**COUNTY OF SAN MATEO  
PLANNING AND BUILDING DEPARTMENT**

**SUBJECT:** EXECUTIVE SUMMARY: Consideration of a Coastal Development Permit, Non-Conforming Use Permit, and Design Review Permit to permit construction of a new 2,041 sq. ft., two-story single-family residence, including a 206 sq. ft. attached one-car garage, located on a 4,484 sq. ft. undeveloped legal parcel in the Moss Beach area of unincorporated San Mateo County. The project is appealable to the California Coastal Commission.

County File Number: PLN 2020-00392 (Love)

1 West (Front)  
1/4" = 1'-0"

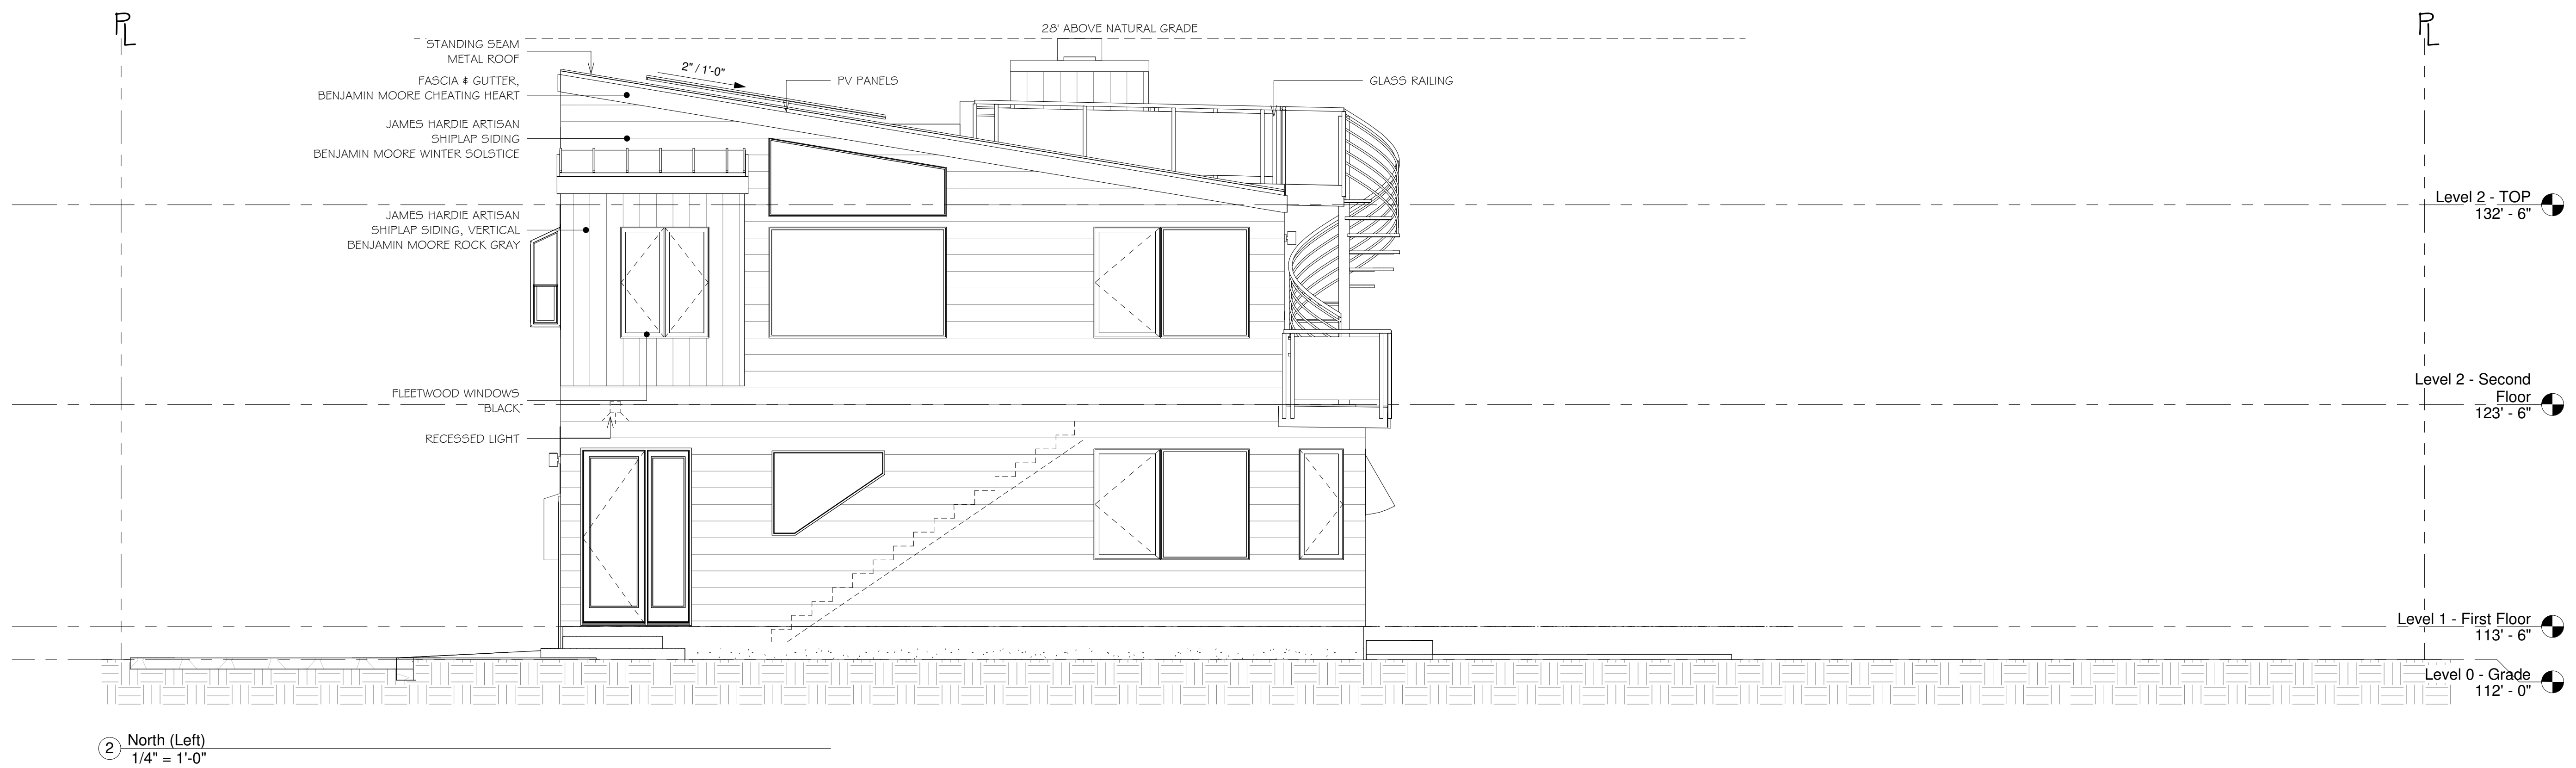
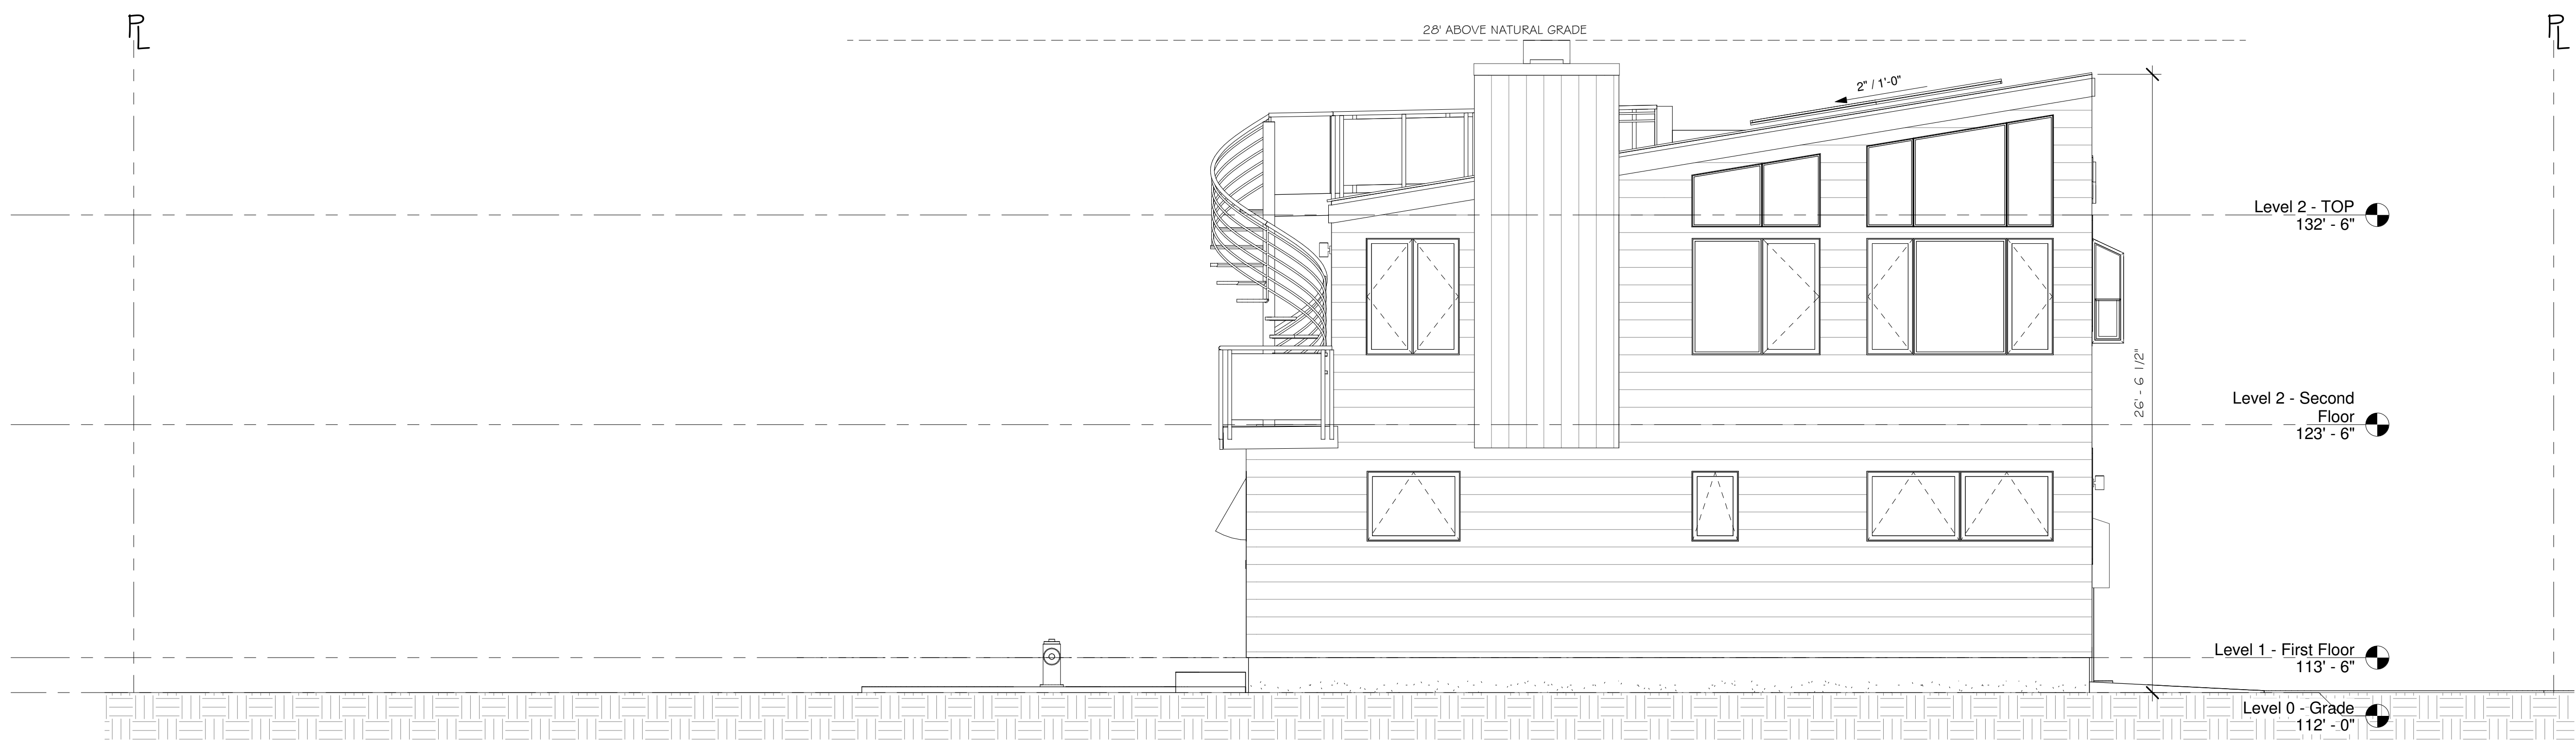
-Add bay window at office / guest, centered above windows below, with accent siding, to better meet Section 6565.20 (D) ELEMENTS OF DESIGN; e. wall articulation standards.

-Add Eyebrow roof or trellis over garage door; incorporate downlight into roof

4. The applicant shall indicate the following on plans submitted for a building permit, as stipulated by the Coastside Design Review Committee.
  5. Bay window shall be added at office / guest room, centered above windows below, with accent siding, to better meet Section 6565.20 (D) ELEMENTS OF DESIGN; e. wall articulation standards.

24. An eyebrow roof or trellis over garage door shall be added so that downlight is incorporated into the roof.
25. Near bedroom 2, one of the shrubs shall be changed to 1-2 New Zealand Christmas trees, or plantings of equivalent size, to provide screening adjacent to neighbor's house.
